# EMISSION RECALL BULLETIN

Subject: **Emission Recall D19R2**  
**GHG17 MDEG Platform DD8 – Software Reprogramming For California Inspection and Maintenance**

Figure 1 - DiagnosticLink® Identification Screen

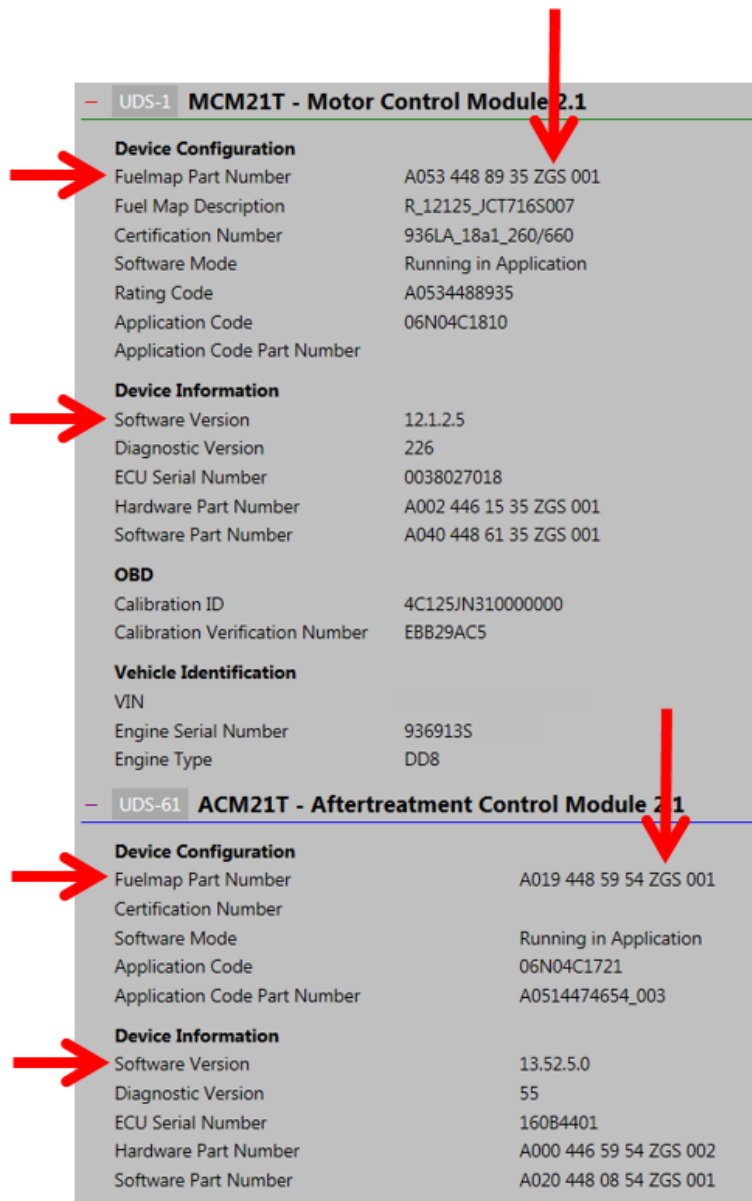
5. On the Identification screen, check the current MCM and ACM software and fuel map level. Listed below are the **MINIMUM** levels required. See Figure 1 for an example of the Identification screen for the MCM and ACM.
  - a. MCM **software 12.2.2.2** and fuel map version **ZGS 001**
  - b. ACM **software 13.54.2.0** and fuel map version **ZGS 001**
  - c. CPC **software R42\_00\_000A**
